## ADDENDUM NO. 1 TO PROJECT NO. 47543

### CONSTRUCTION AND ELECTRICAL WORK PROVIDE SALT STORAGE BUILDING 1 & REPLACE ROOF BUILDING 2 ROUTE 20 AND 400 WEST SENECA, NY

February 28, 2025

**DRAWING NUMBER:**  
AS- 101

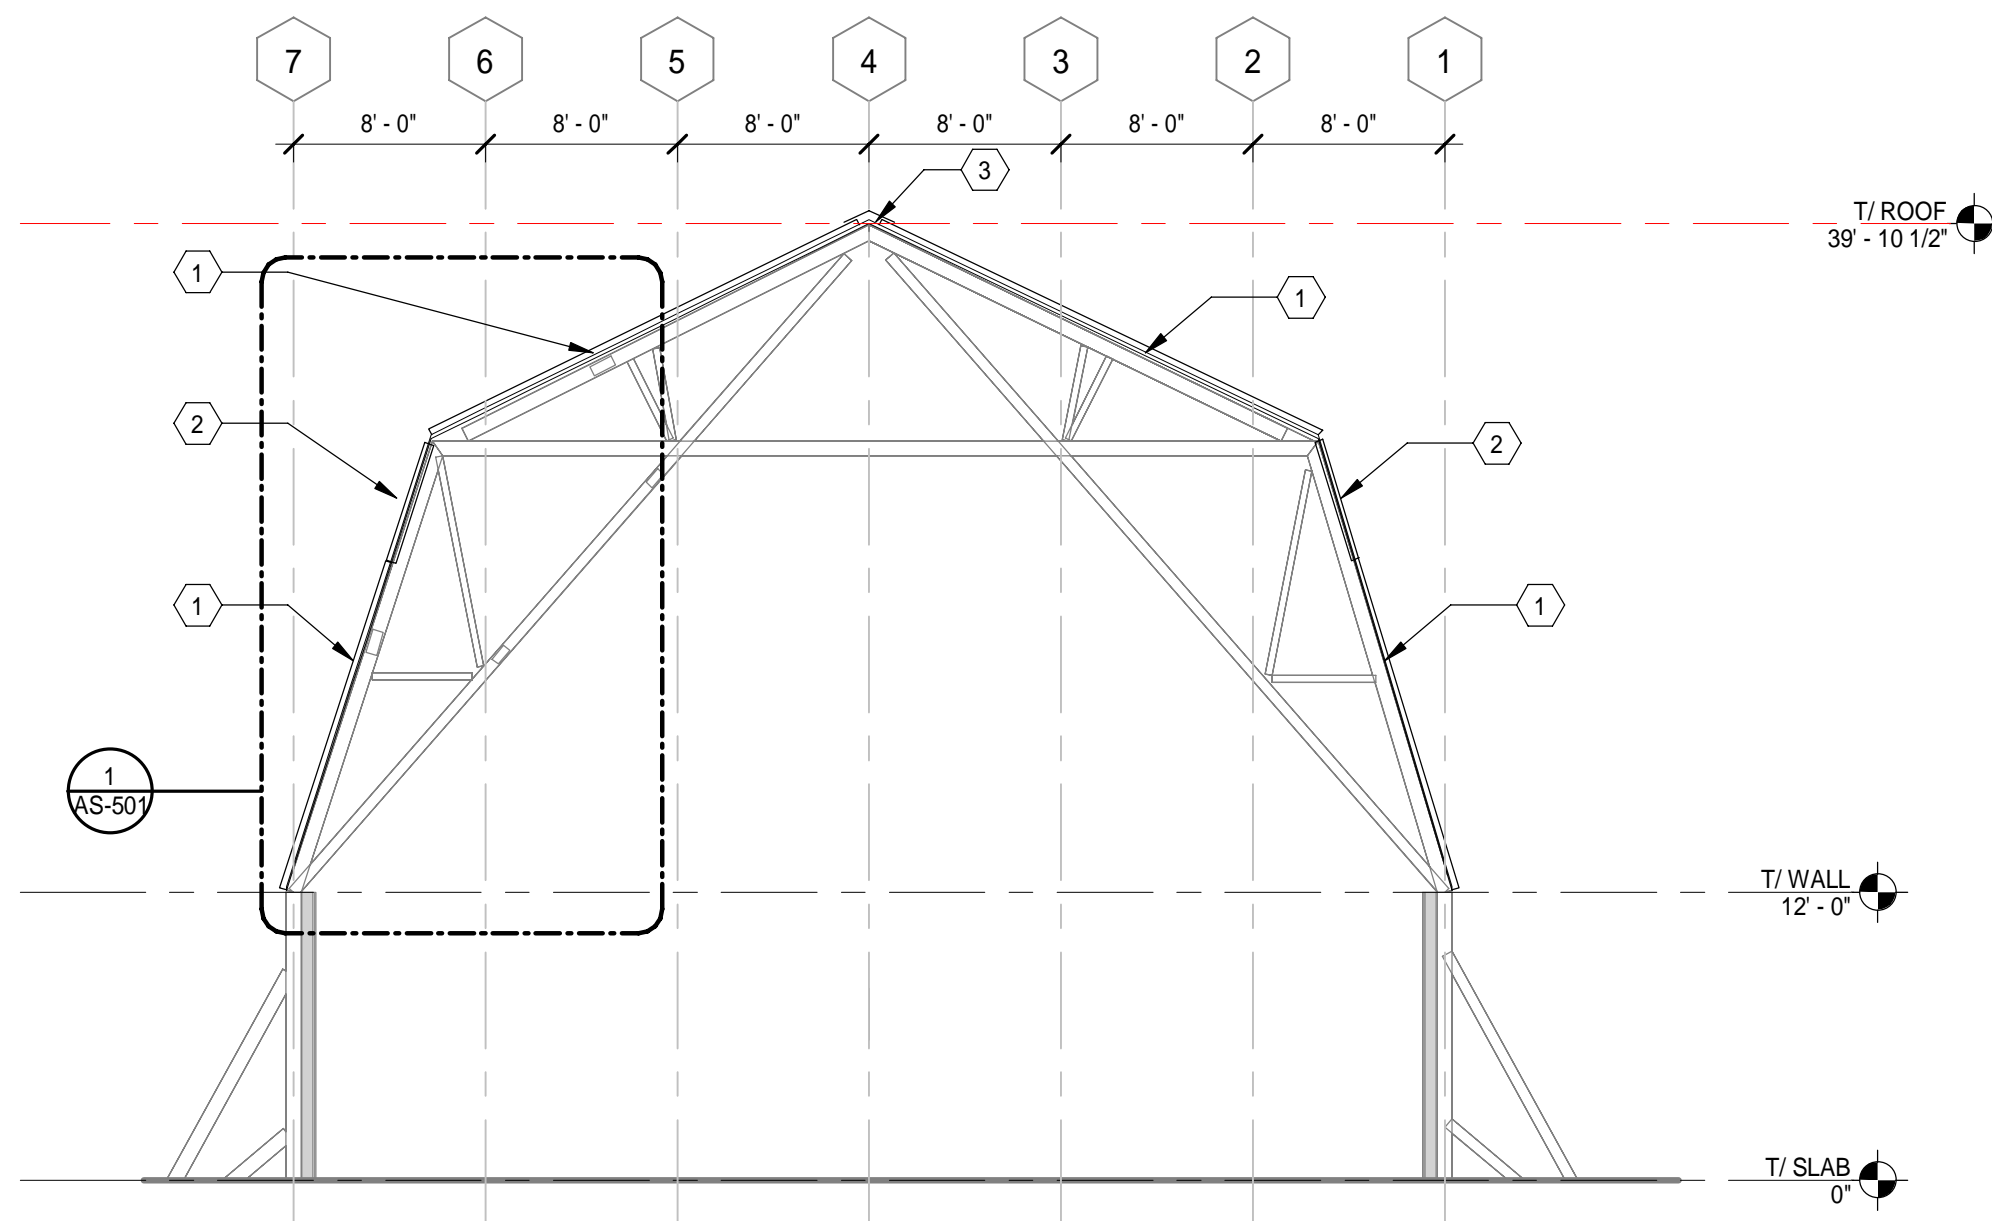
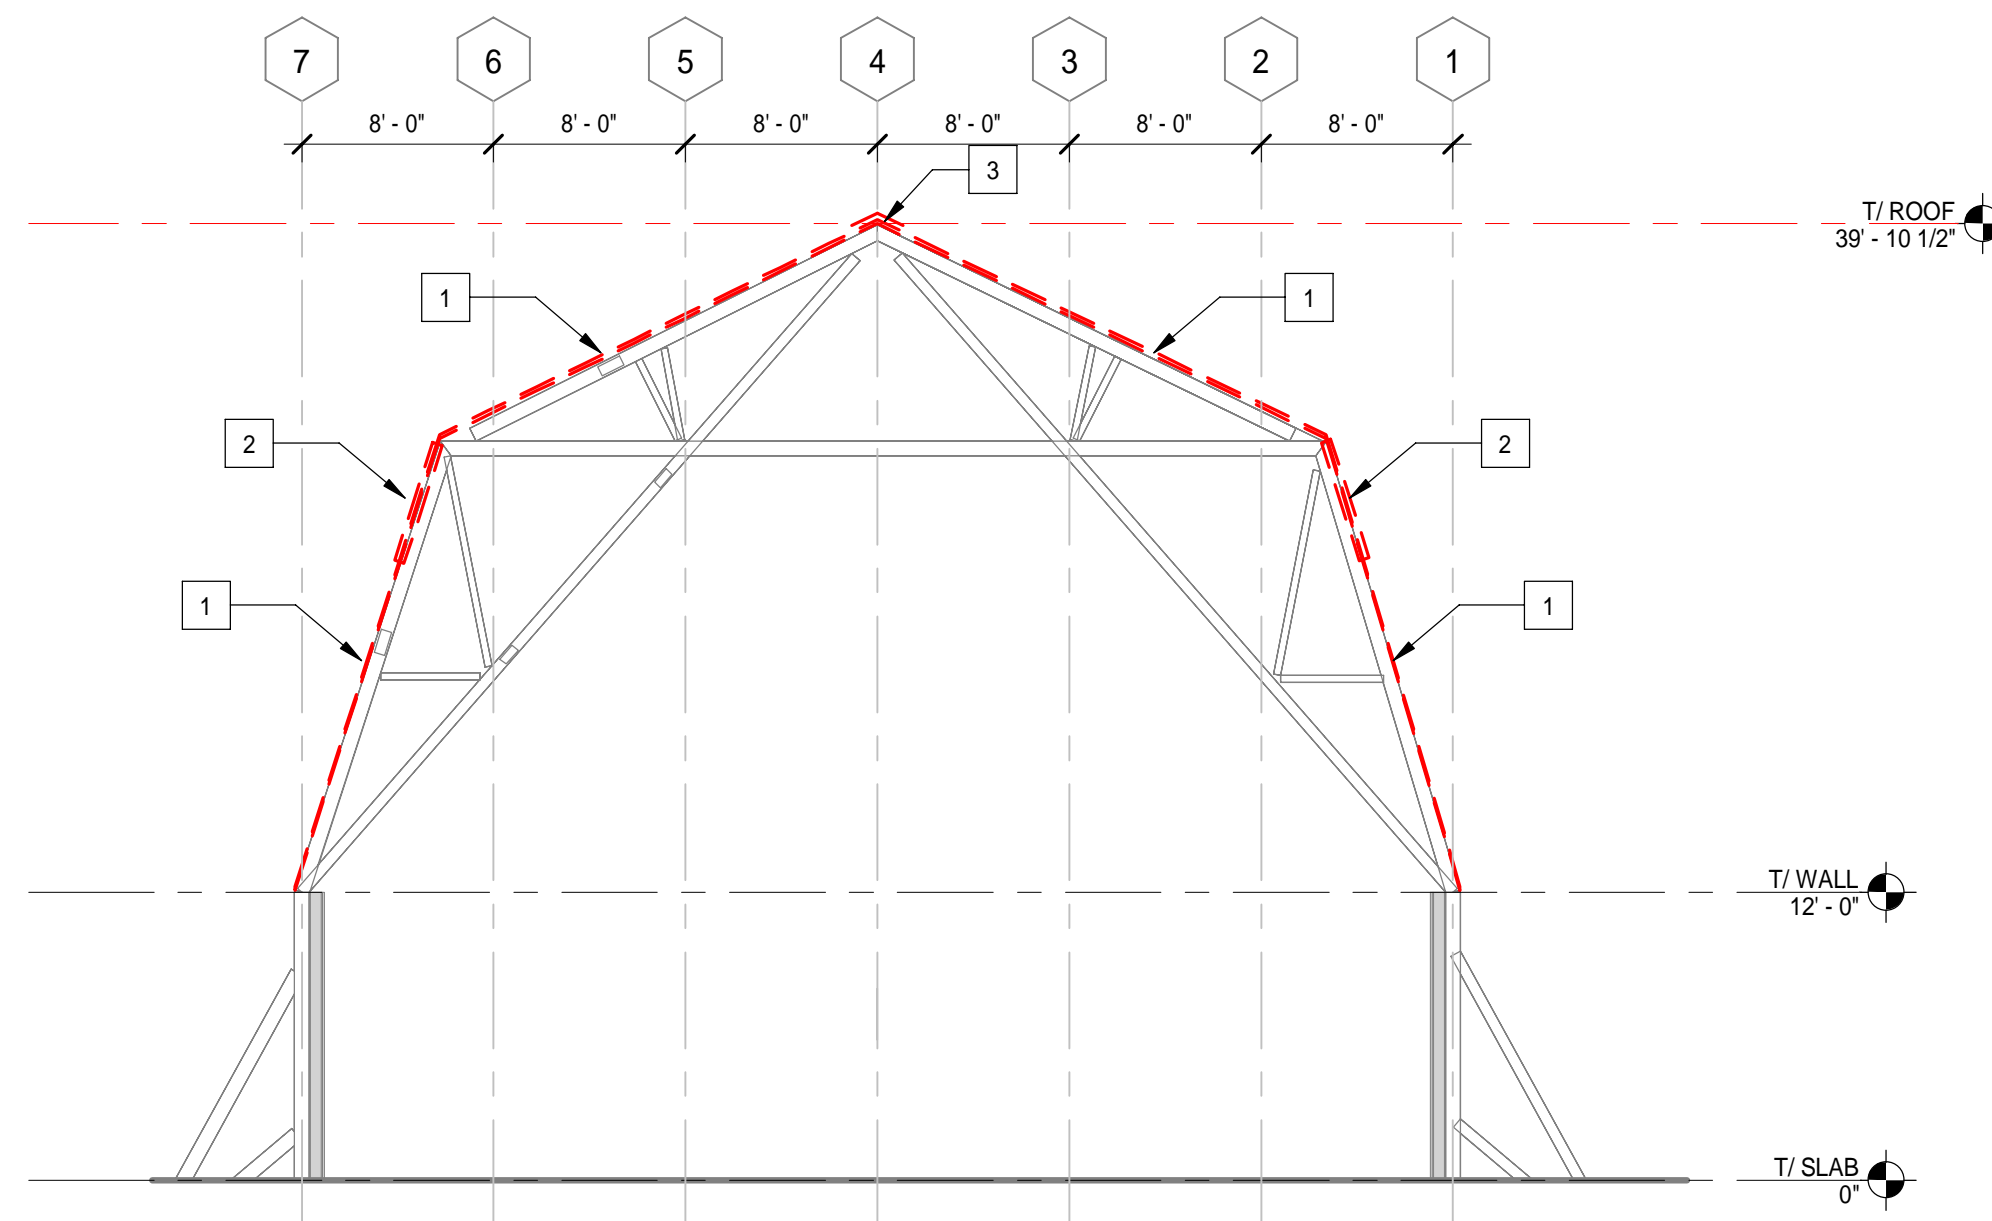
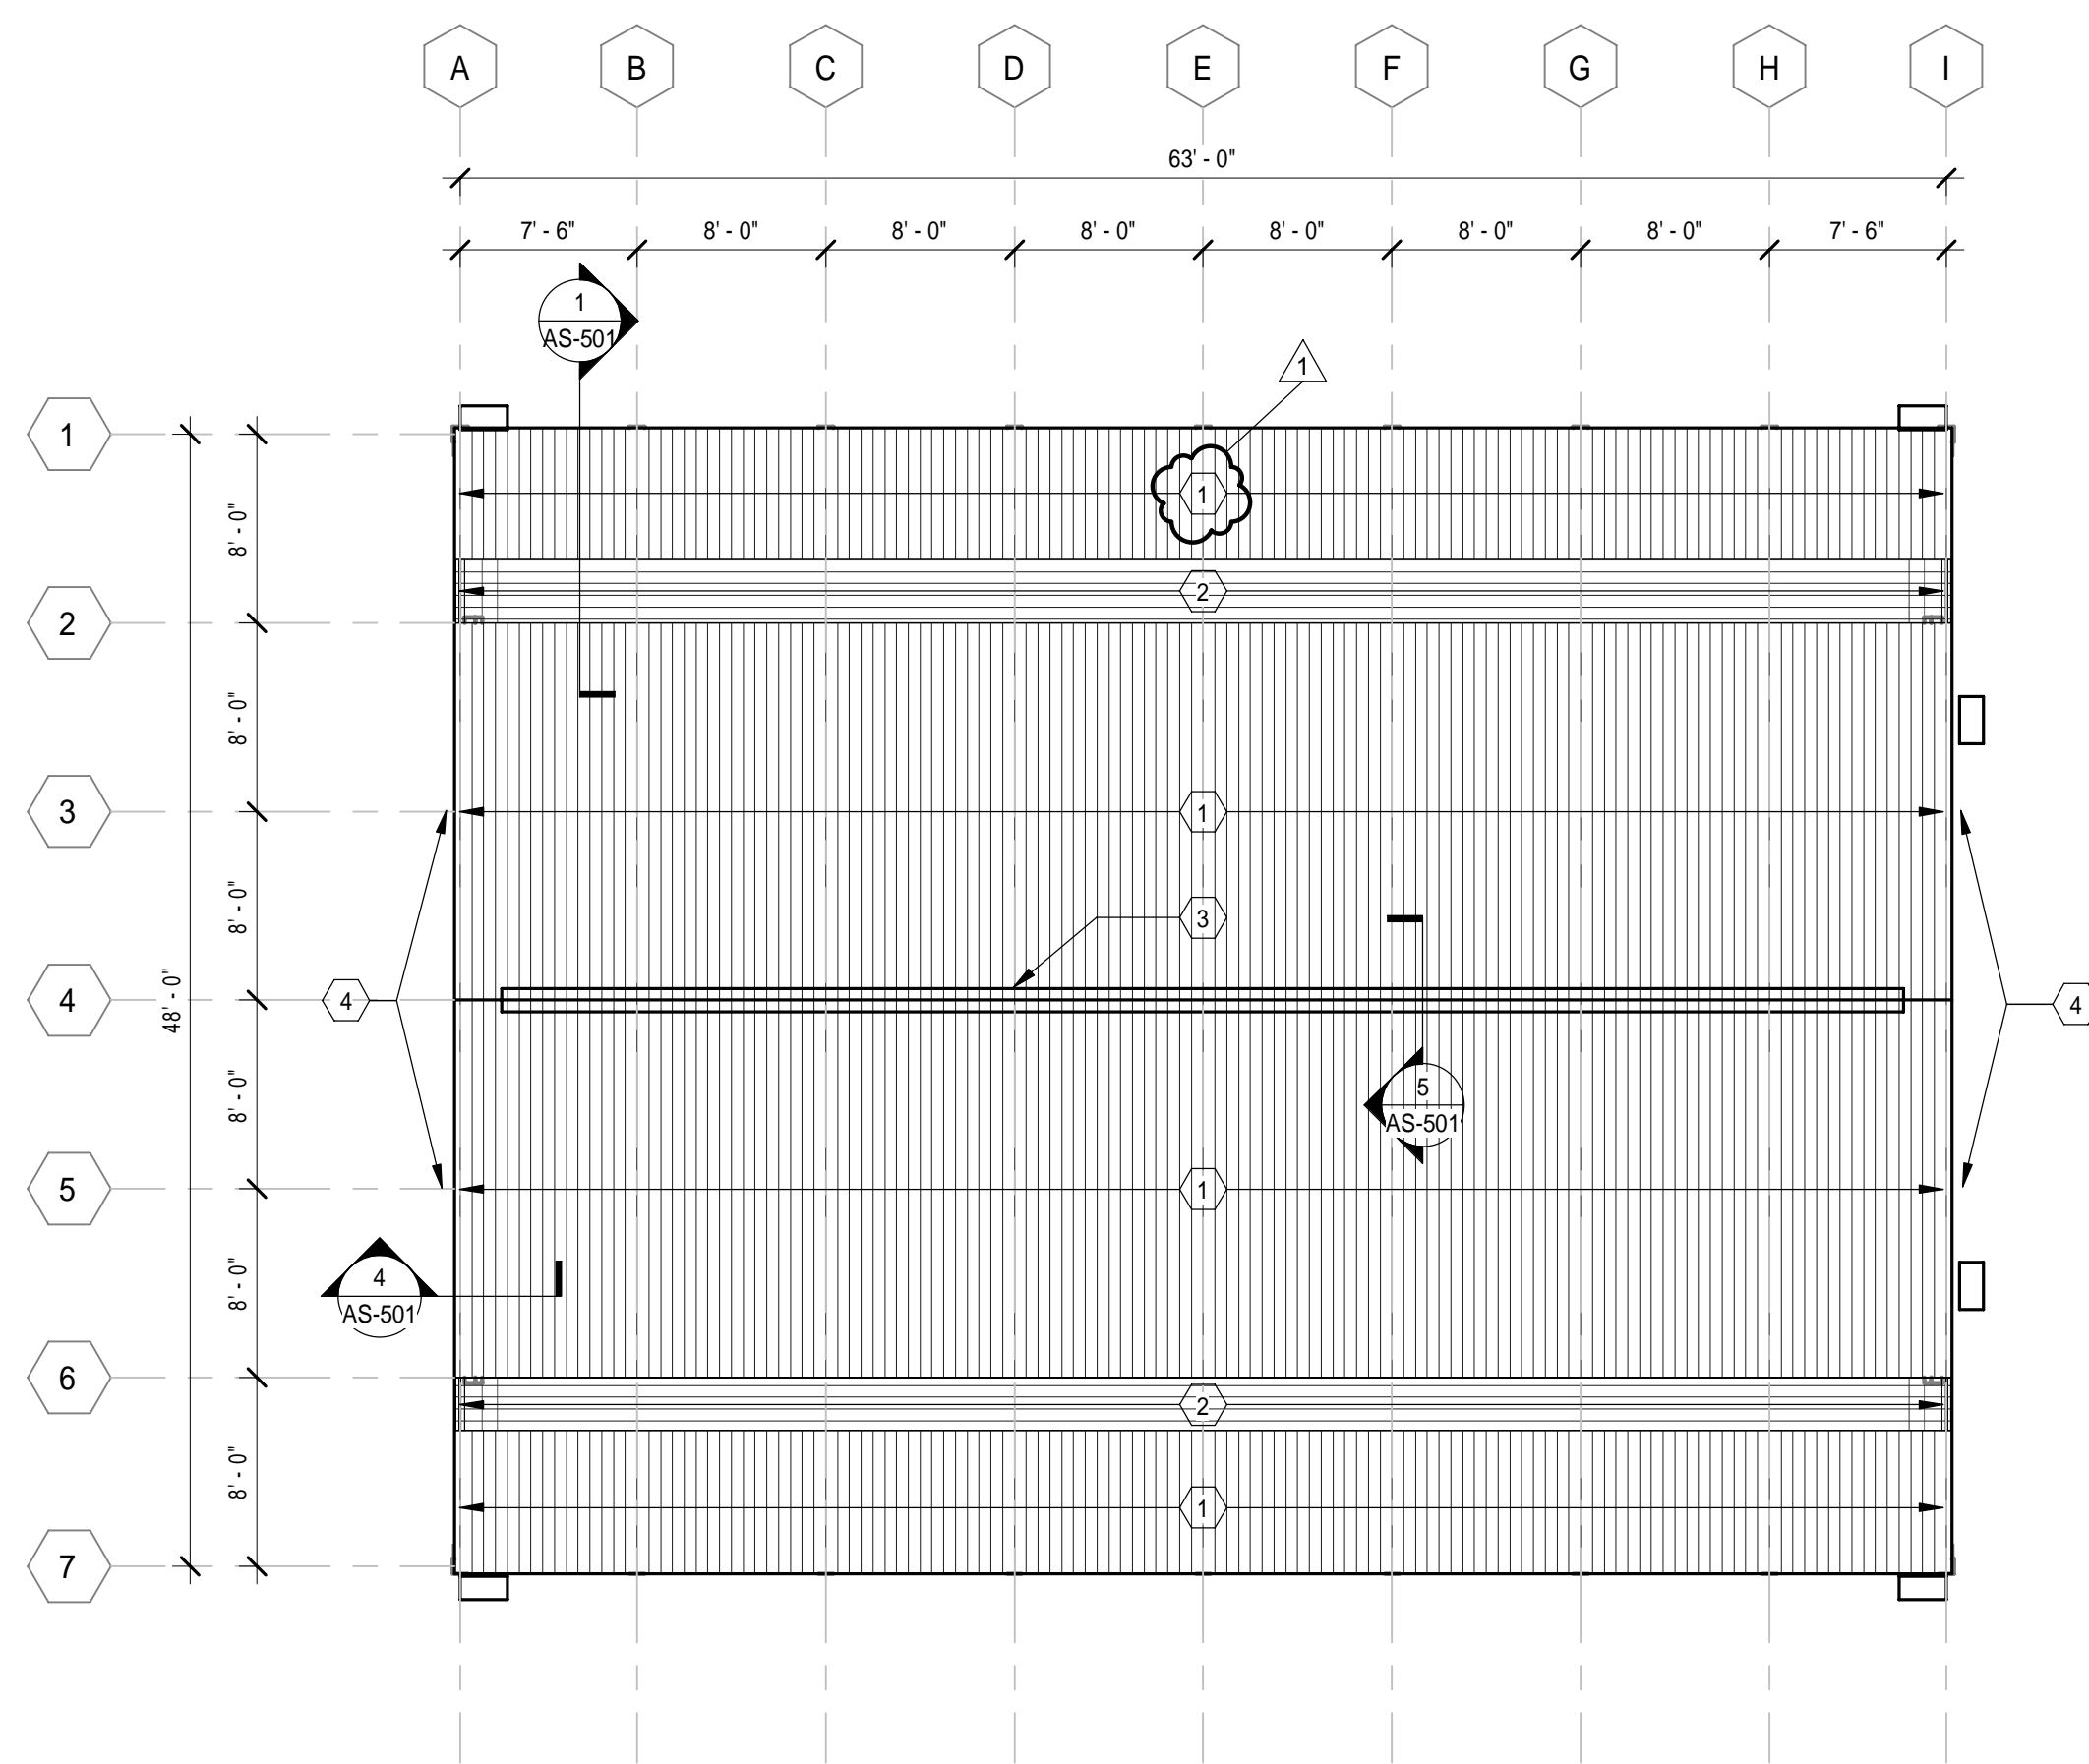
“5. Provide 200 linear feet of silt fence, location to be determined by director’s representative.”
5. Revised Drawings:
  - a. Drawing Nos. AS-101, S-102, S-201, noted “ADDENDUM #1 02/28/2025” accompany this Addendum and supersede the same numbered originally issued drawings.
